Subject: Preliminary Plat Review Comments – Springs at Cherry Lake: Application #2014-87

On behalf of our client, L&D, LLC, we are responding to City Staff's preliminary plat review comments for Springs at Cherry Lake subdivision, Application #2014-87. Each comment is reiterated below and followed by our response.

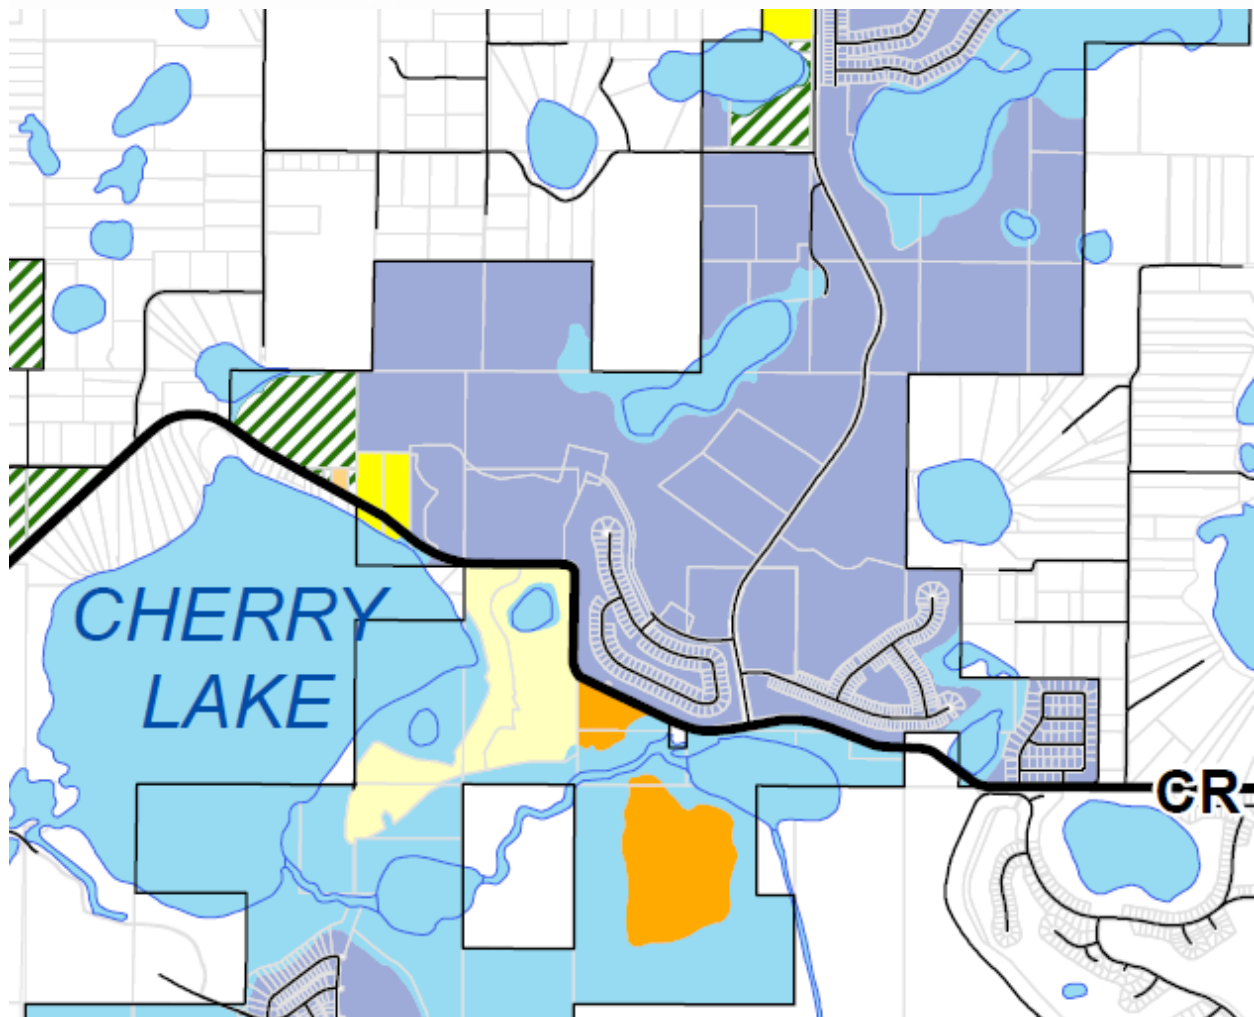
2. Application lists one parcel. Property record cards submitted in support of Certificate of Title Information includes two properties with a property record card for the two properties. Sec. 145-46(d)(4).

As the City is aware there are 3 projects under review that share common infrastructure. Previous property divisions did not accurately reflect the current design therefore there are minor areas that currently are not owned by the Owner of the Springs. Prior to approval and Final construction plans

and as discussed with the City Attorney, it shall be demonstrated that property ownership is accurately reflected by providing the appropriate recorded documents.

ZONING

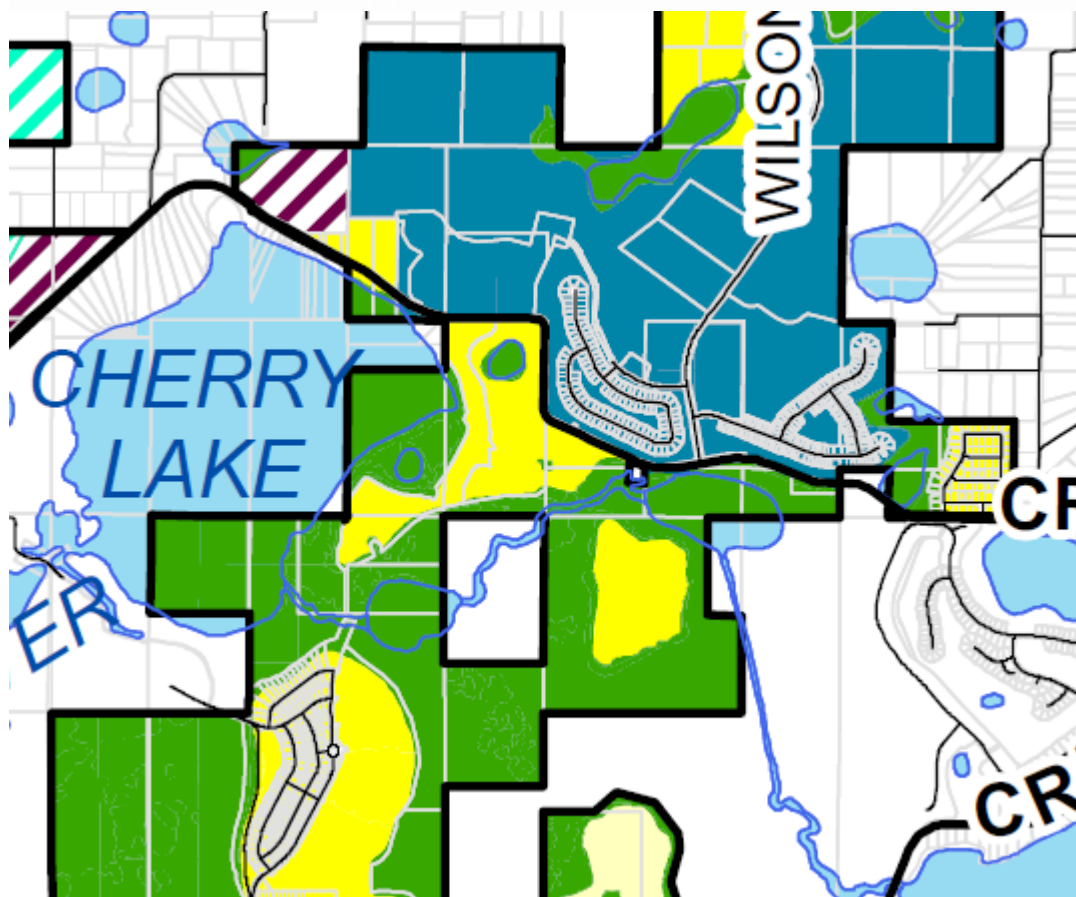
4. The Application indicates the property is zoned R-2 and has an existing land use designation of SFMD – Single Family Medium Density while Sheet 4 states the land use is North Residential Neighborhood Development and Conservation. The January 3, 2006 staff report for the Annexation Ordinance indicates at a future date the property will be considered for a future land use designation of Groveland North Residential Neighborhood Development with Conservation, and will thereafter receive a rezoning. Please provide copies of the City of Groveland FLU Ordinance and zoning ordinance for the Property. Additional comments relating to open space requirements, etc. may be forthcoming upon receipt and review of the FLU and zoning ordinances.

The exhibit above is taken from the January 5, 2011 City of Groveland adopted Zoning Map found on the City of Groveland's Web site. References to discussions occurring in 2006 are out of date and are no longer relevant in regards to current zoning of this property. The adopted City of Groveland Zoning Map identifies the property as R-2 and property to the;

- North and to the East as PUD / Estates at Cherry Lake, currently under active development
- East as R1A
- South and West as Lakes or Ponds
- West outside the City of Groveland in Lake County
